MEMORANDUM

**Re: Shepherdstown Opera House Renovation
ADDENDUM No. 3**

The following information amends or supersedes the current issue of architectural, structural, and MEP drawings/specifications dated June 22, 2020 and addendums #1 and #2.

MAIN LEVEL & MEZZANINE PLANS

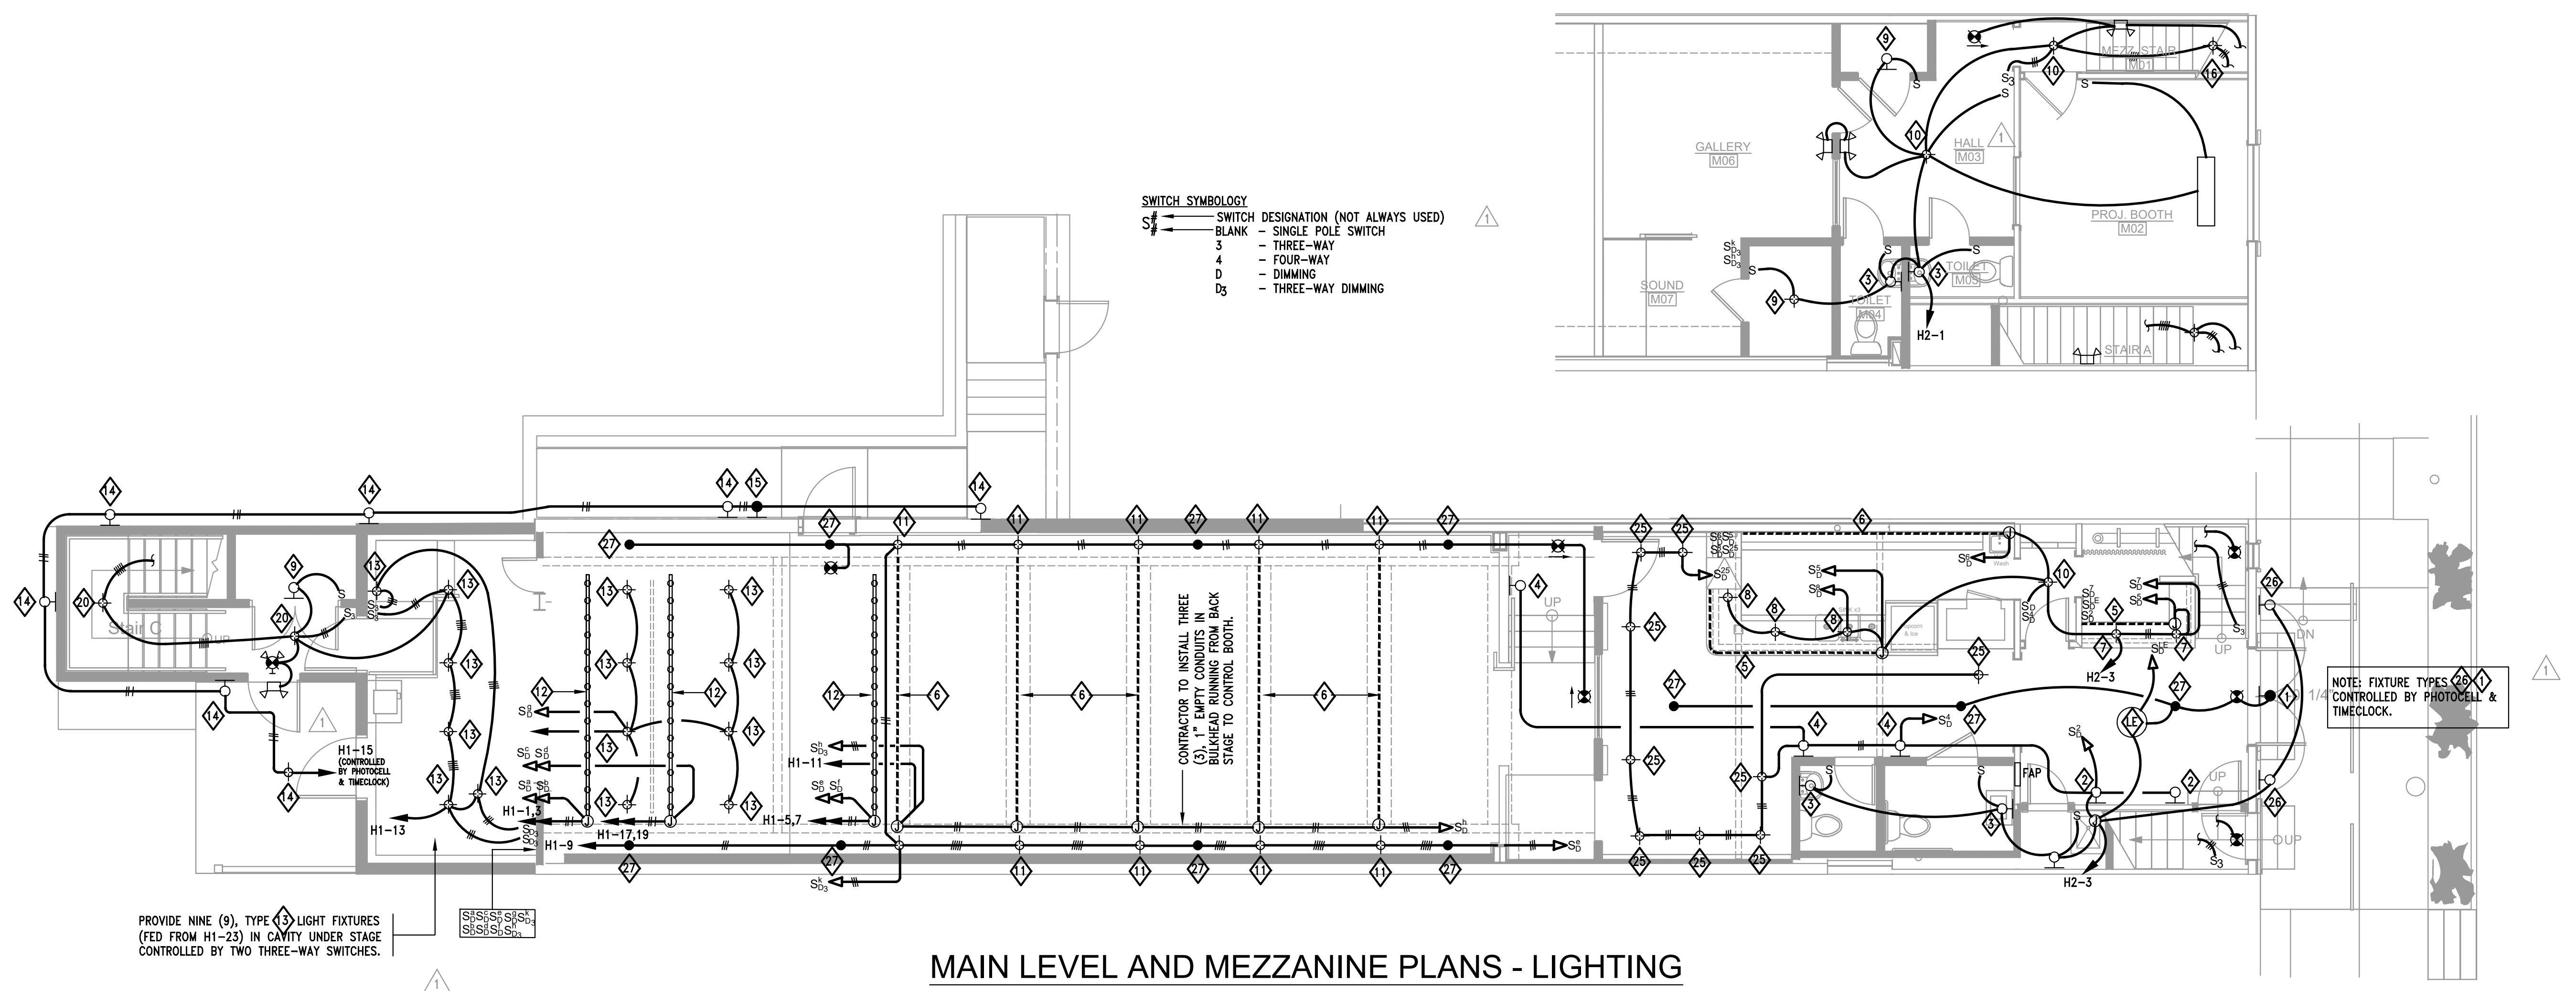
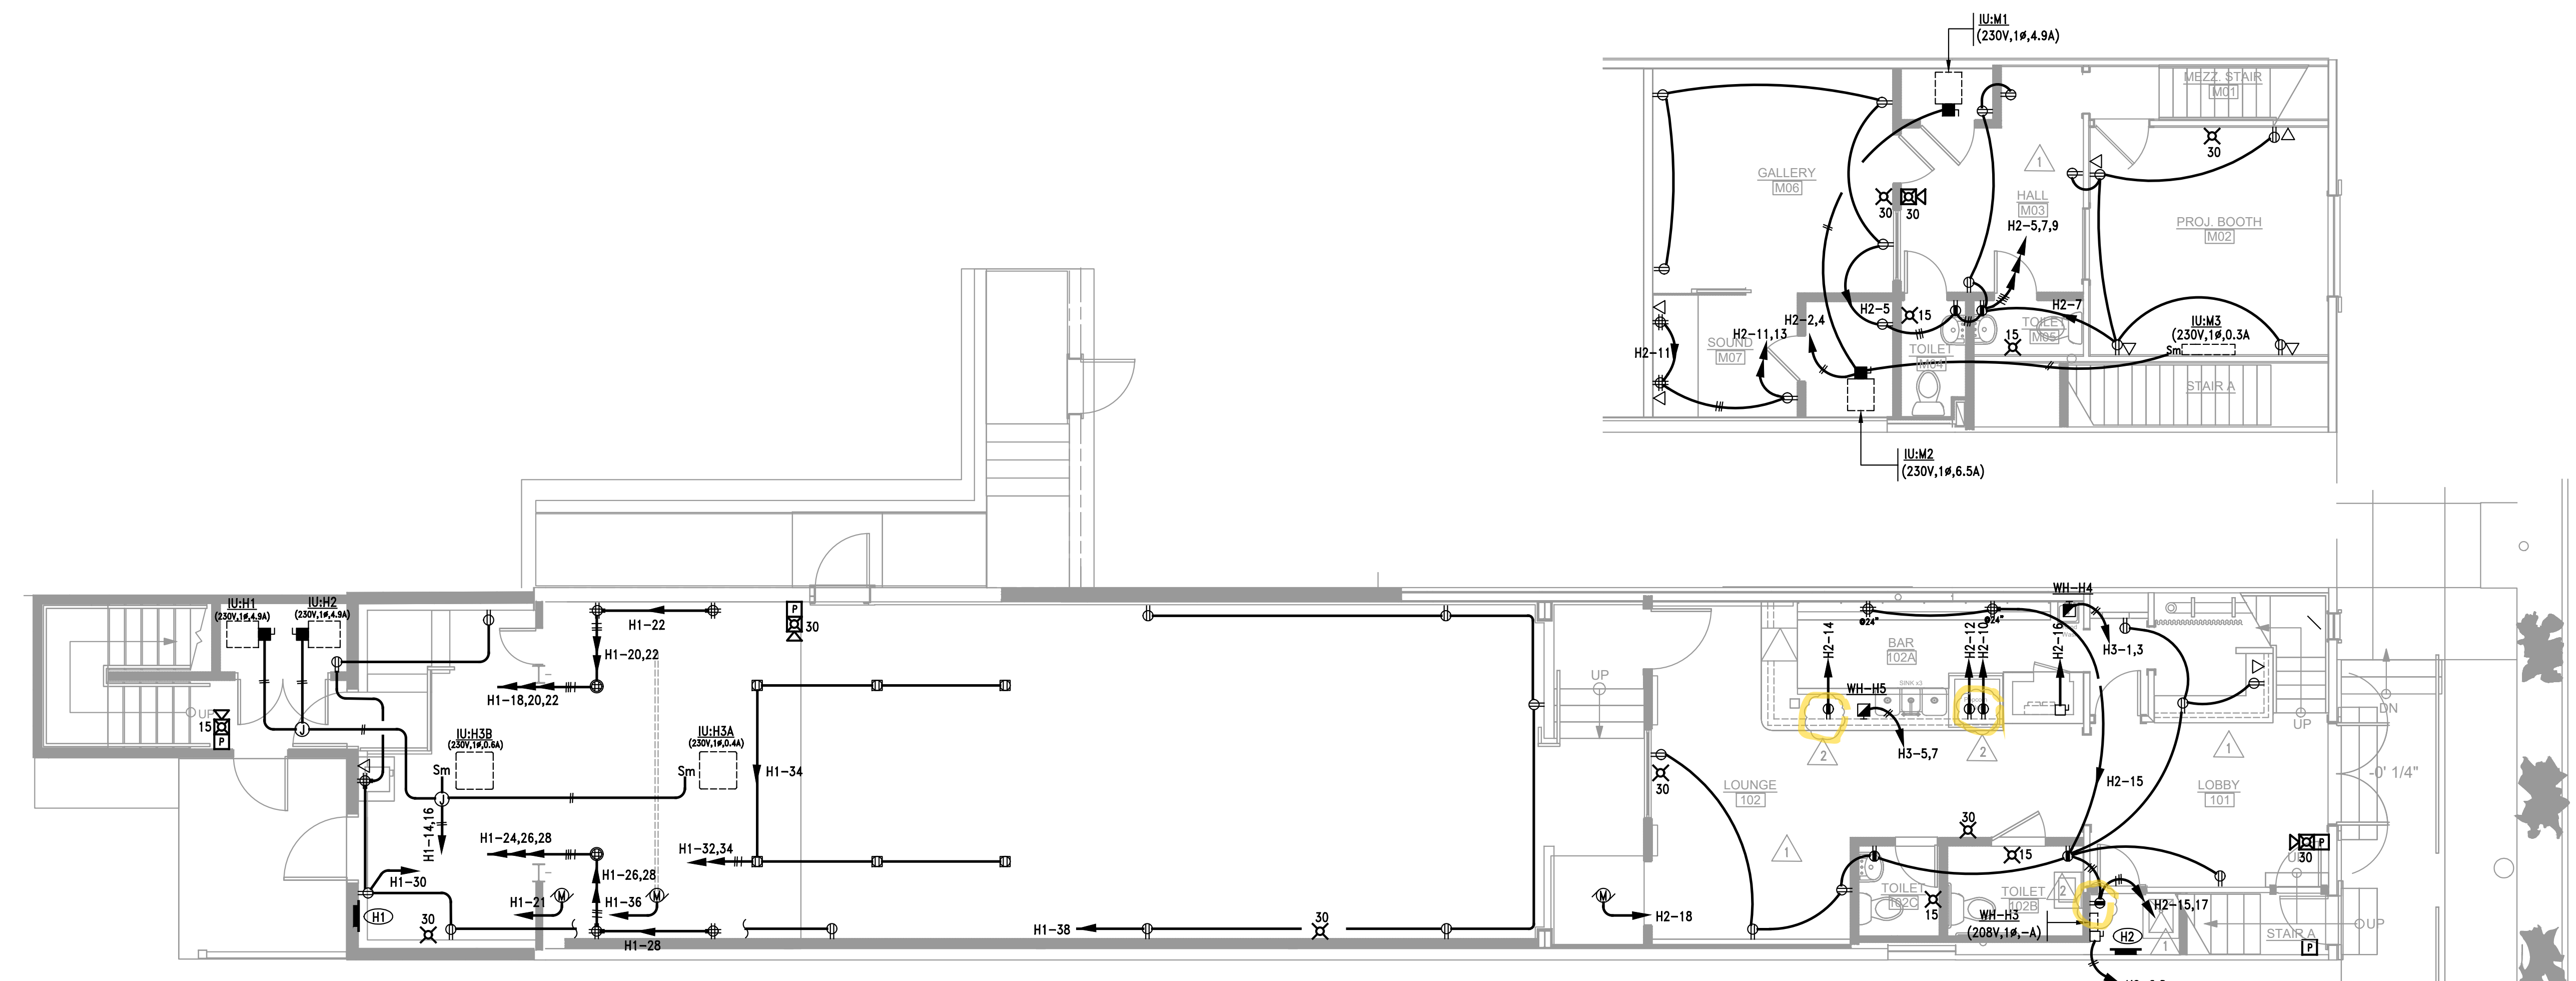
39. The Bid Due Date has been extended to 3pm, Friday August 7, 2020.
40. Additional outlets require GFCI. See revised E1.1 and E1.2 power and lighting plans showing clouded receptacles.
